# HISTORIC AND DESIGN REVIEW COMMISSION

October 02, 2024

**HDRC CASE NO:** 2024-323  
**ADDRESS:** 509 MADISON ST  
**LEGAL DESCRIPTION:** NCB 749 BLK 8 LOT 3 EXC N IRR 7.13 FT AND EXC W IRR 2.5 FT  
**ZONING:** RM-4, H, RIO-4  
**CITY COUNCIL DIST.:** 1  
**DISTRICT:** King William Historic District  
**APPLICANT:** Christopher Rocha/Master Contracting  
**OWNER:** BICOASTAL VENTURES LLC  
**TYPE OF WORK:** Carport Construction  
**APPLICATION RECEIVED:** September 12, 2024  
**60-DAY REVIEW:** November 11, 2024  
**CASE MANAGER:** Caitlin Brown-Clancy

## REQUEST:

**FINAL "AS-BUILT" SURVEY**

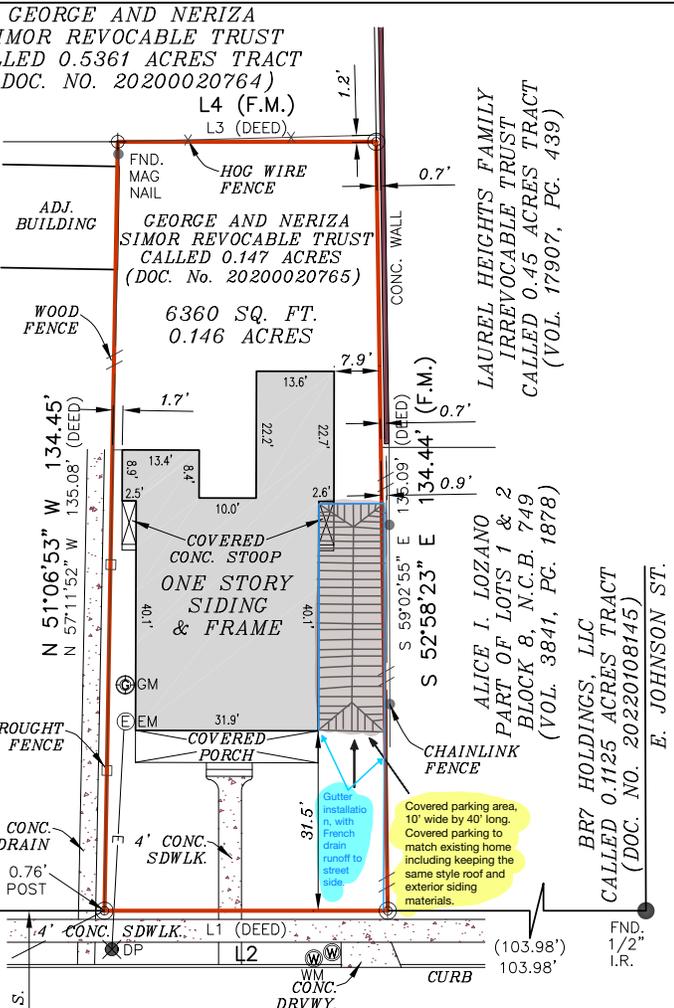
c. **CARPORT: SETBACKS** – The applicant has submitted drawings proposing two separate setbacks to for the new accessory structure. Guideline 5.B.ii for new construction stipulates that new garages and outbuildings should follow the historic orientation and setbacks common in the district. Additionally, the Unified Development Code stipulates that carports may be erected behind the minimum front setback require in the applicable zoning district, however, in some instances, historic setbacks are not consistent with UDC requirements, and a variance may be required. The applicant is responsible for complying with all zoning setback standards and filing for a variance with the Board of Adjustment if applicable. Staff finds the proposal of setting the carport back to align with the front wall façade and fully behind the front porch appropriate. Staff does not find the proposal of aligning the carport with the front porch façade appropriate.

1. The carport is set behind the front façade wall plane (fully behind front porch).
2. That fully dimensioned and to-scale drawings that meet the requirements be submitted to staff in order to receive a Certificate of Appropriateness (COA).

**FINAL "AS-BUILT" SURVEY**

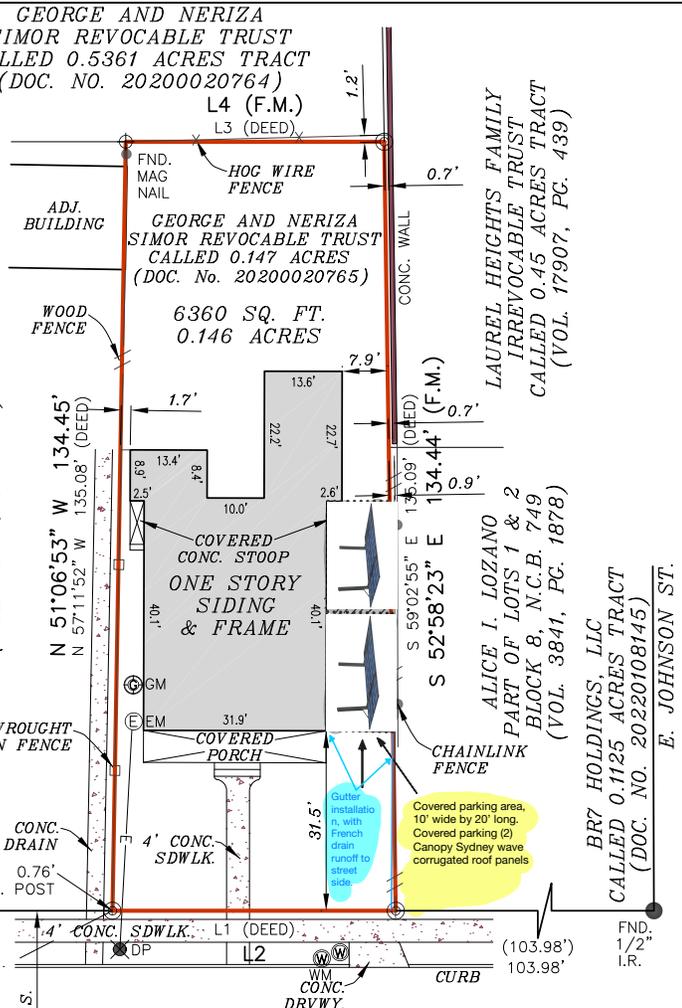
e. **CARPORT: ROOF FORM & MATERIALS** – Option 1 features fully wood columns, and a hipped roof clad with standing seam Galvalume and a hand-crimped ridge in keeping with the primary roof form and materiality. Option 2 features a mono-pitch roof form with aluminum framing and polycarbonate corrugated panels. The Guidelines for New Construction 3.A.i states that materials should complement the type, color, and texture of those found in the historic district. 2.B.i stipulates roof forms should be consistent with those predominately found on the block. Staff finds Option 1 appropriate. Staff does not find Option 2 appropriate.

Staff does not recommend approval of Option 2 to construct a detached metal cantilevered carport along the Northern side of the property based on finding e.
